URGENT MEDICAL DEVICE CORRECTION

Medfusion™ 3500 and 4000 Syringe Infusion Pumps

April 19, 2022:

Medical Device Correction Notice: Medfusion 3500 and 4000 Syringe Infusion Pumps
Smiths Medical Ref: 3012307300-03/28/2022-002-C

Figure 2: Green light indicates IVOT Infusion Continues after System Failure

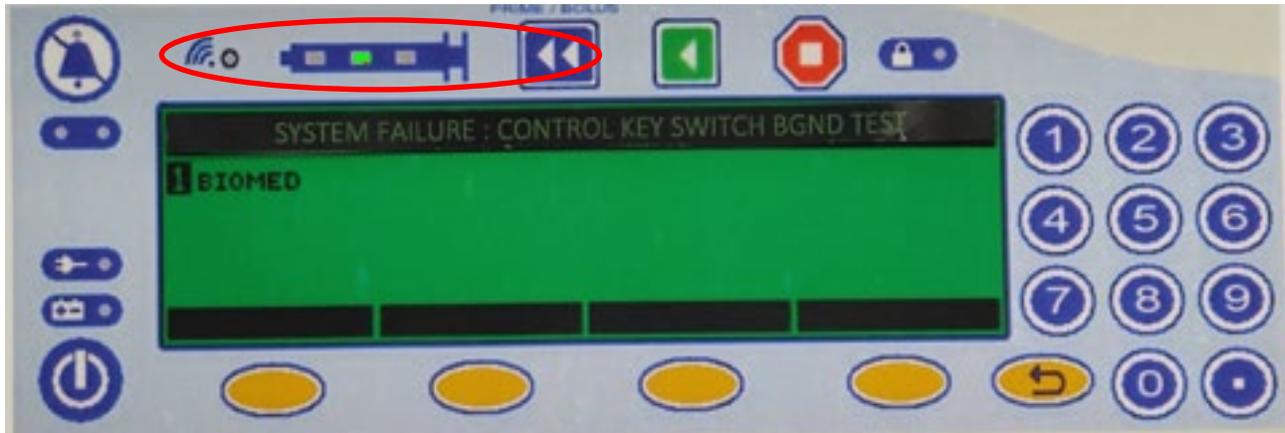
The Intermittent Volume Over Time (IVOT) delivery mode allows the specification of a delivery volume for a specific delivery time, after which the delivery stops for a programmed interval, then the pattern recycles. **If a System Failure alarm occurs during the small window of time when**

the pump is transitioning from IVOT delay to IVOT delivery, the pump may continue to run without the ability to terminate infusion via the Stop or Power keys. In the following figure (Figure 2), the green light indicates infusion is ongoing even though the pump displays a System Failure alarm.

Failure of the pump to stop running in a System Failure condition could result in over-delivery of medication which could cause serious harm or death. **To date, Smiths Medical has received reports of one serious injury potentially related to this issue.**

1. **Do not use the IVOT delivery mode until this issue is fixed in a future software update.** Program each infusion separately instead of using the IVOT delivery mode program.

2. If an IVOT delivery mode program is inadvertently programmed and this issue occurs:
 - Immediately remove the syringe from the pump to stop the infusion, and press the Power button to turn the pump off.
